WOOTTON PARISH COUNCIL

Minutes of the **Planning & Environment Committee** meeting held on Wednesday 26th April 2023 at 7pm at
Wootton Community Centre, Harris Way, Wootton, MK43 9FZ.

Appendix One

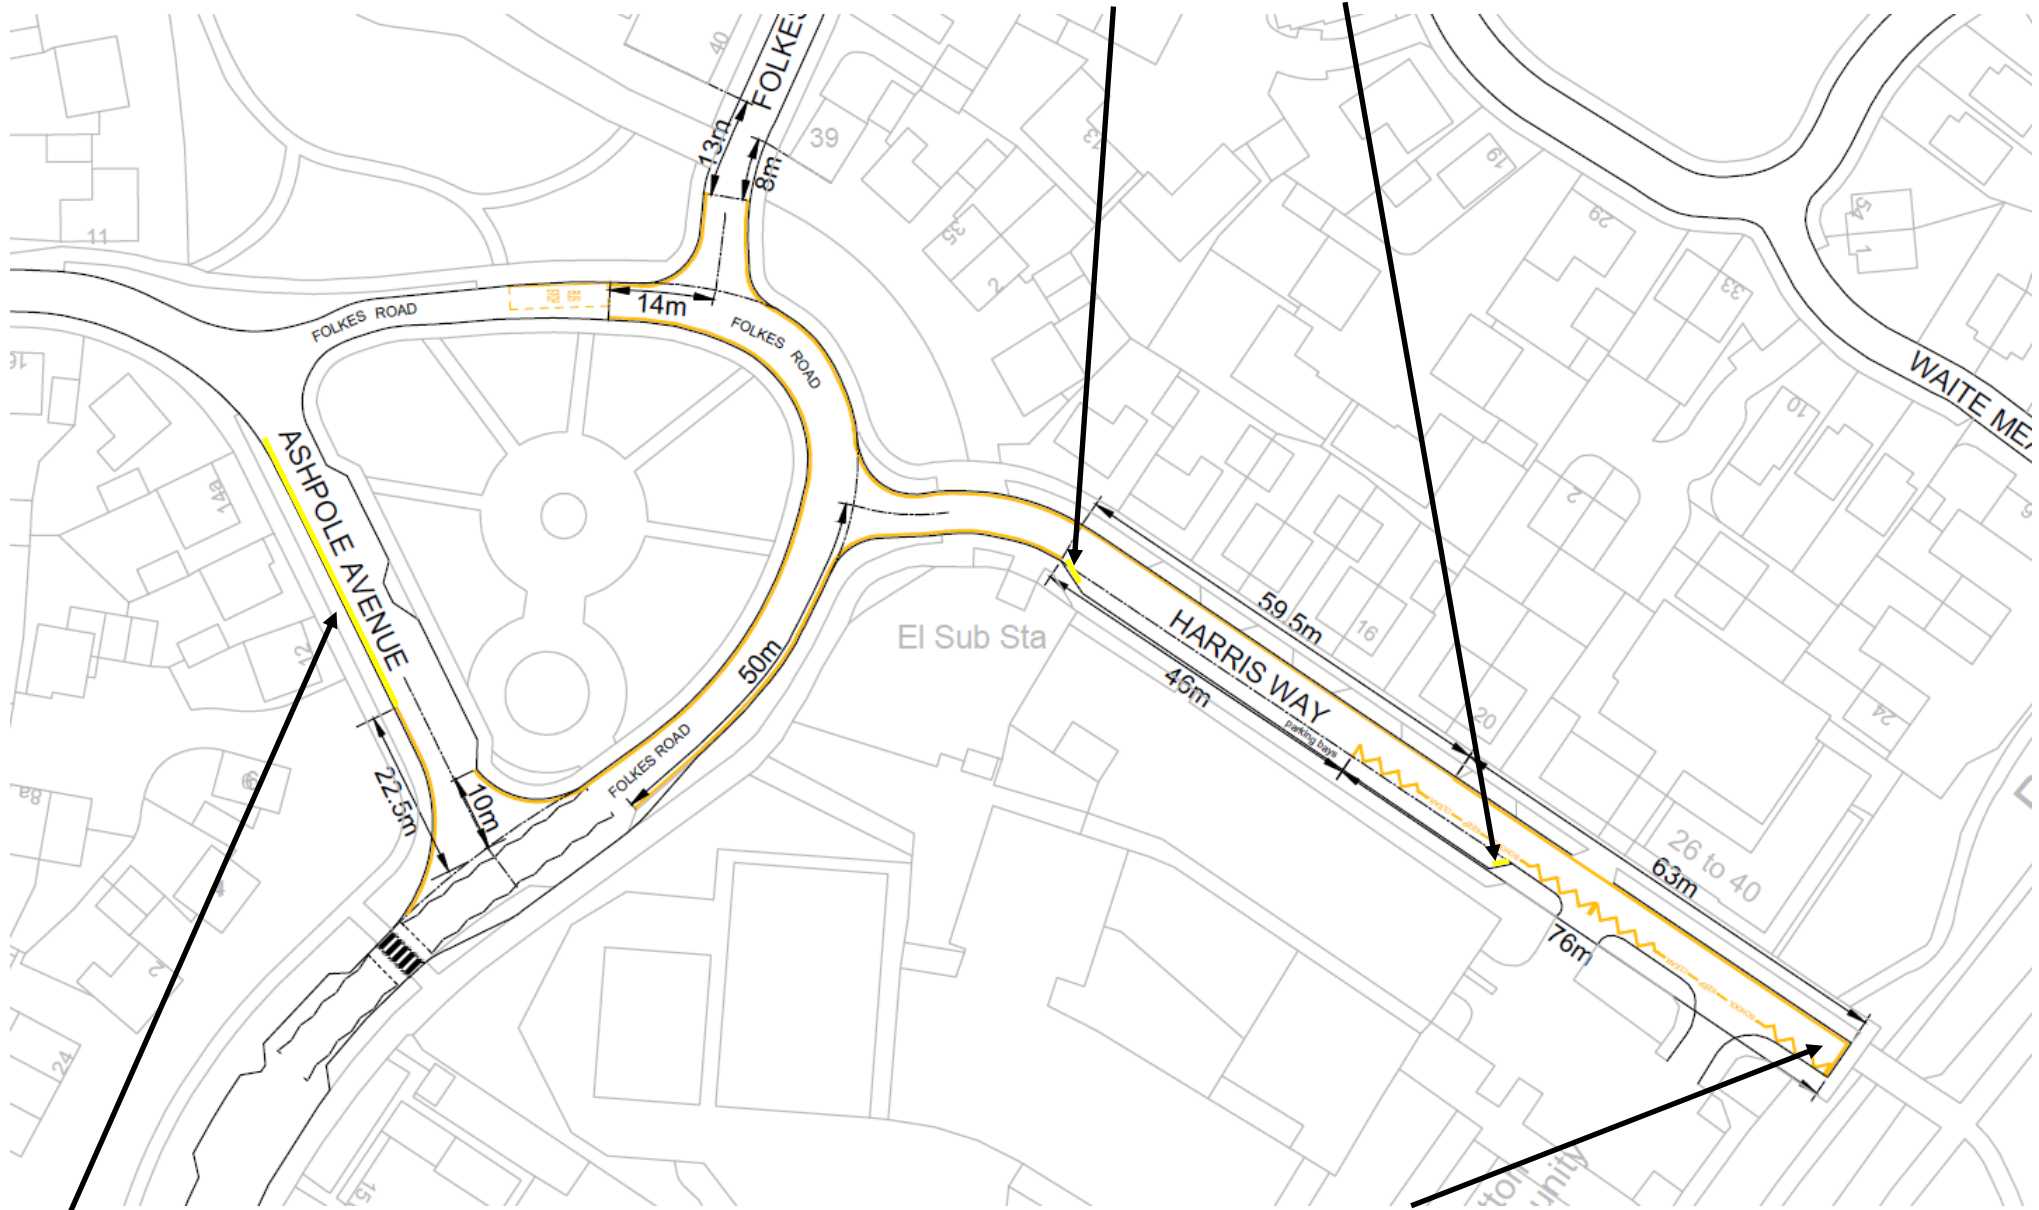
All yellow lines should be double not single.

Additional double yellow lines to prevent cars that are currently parked half in the layby and back of the car in the street

Extend double yellow lines along Ashpole to mirror the lines in place before the road was resurfaced

Hash area as this is the only emergency service access/egress point to the recreational area.
